**Notice of Meeting for the  
Historic and Architectural Review Commission  
of the City of Georgetown  
June 10, 2021 at 6:00 PM  
at Virtual**

# Planning Department Staff Report

File Number: *2021-23-COA*

SHEET TITLE  
Proposed  
Carport  
Floor Plan

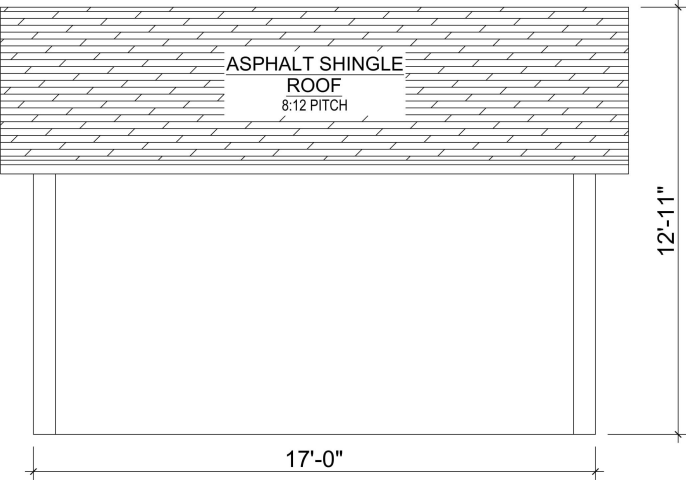
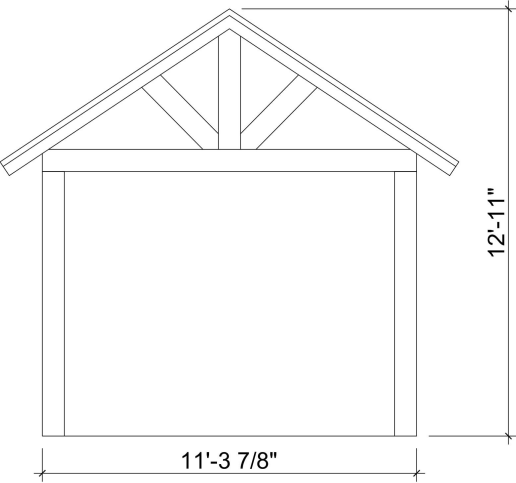
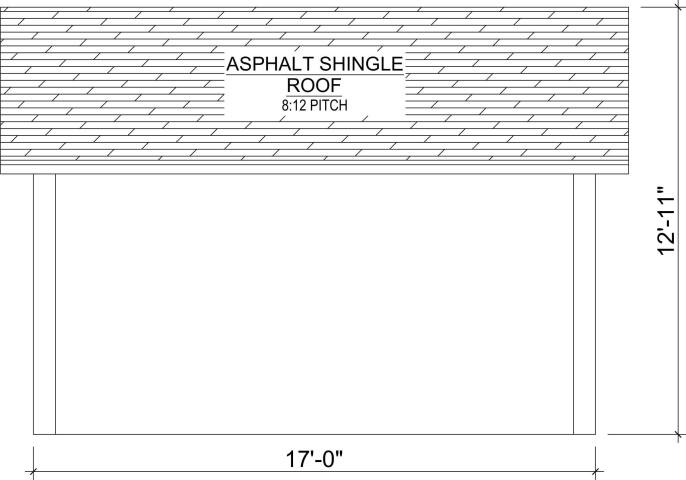
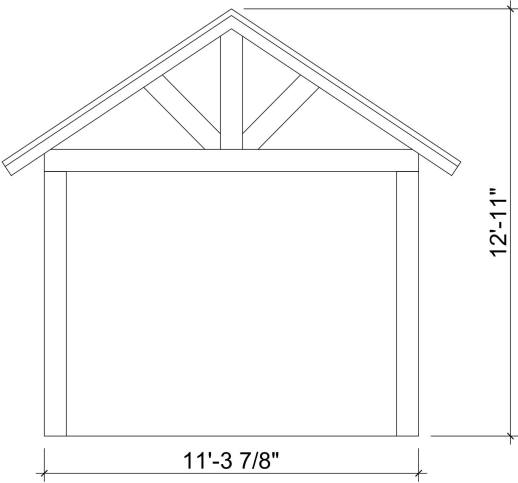
Based on the findings listed above, staff recommends *approval* of the requested 1'-0" side setback modification and *denial* of the 14'-0" and 6'-0" setbacks for the carport. The addition of the carport would create two separate parking spaces in the front setback, which is not compatible with historic development patterns or with surrounding properties, and the carport would have to be modified to comply with building codes to have an enclosed south side, which would be prominent from the street view.

Staff recommends ***approval*** of the requested 1'-0" side setback modification and ***denial*** of the 14'-0" and 6'-0" setbacks for the carport.

# Existing & Proposed Street-Facing Elevations

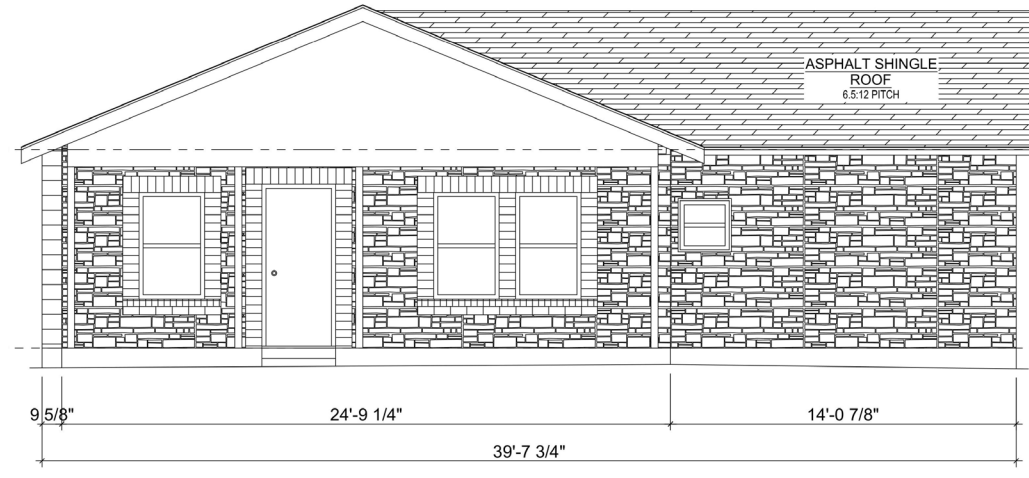
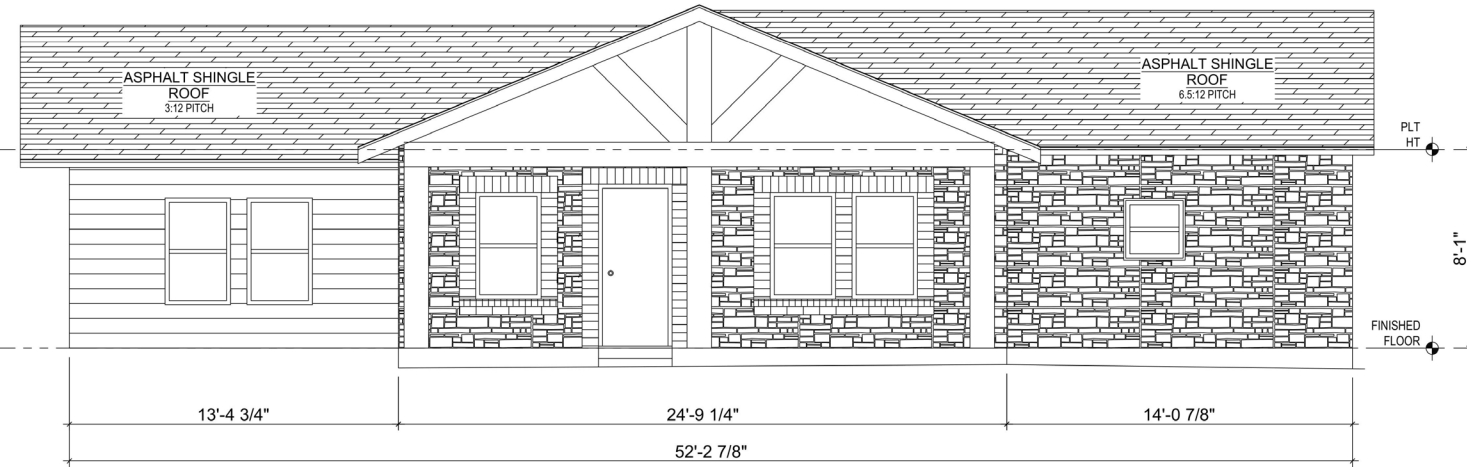
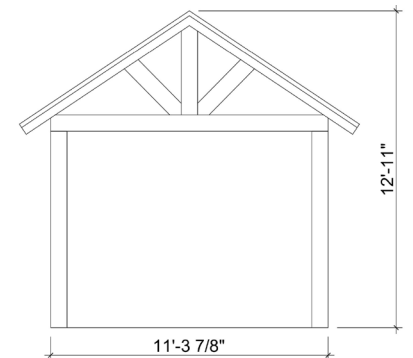
5. The general historic, cultural, and architectural integrity of the building, structure or site is preserved;	<b>Partially Complies</b> The proposed project is compatible in materials and form with the current structure and uses the location of existing or previously existing structures on the site with a scale and massing compatible with the existing structure. However, the proposed living space and carport additions would terminate the driveway in the front setback and provide a secondary, covered driveway for two parking areas, which is not consistent with historic development patterns.
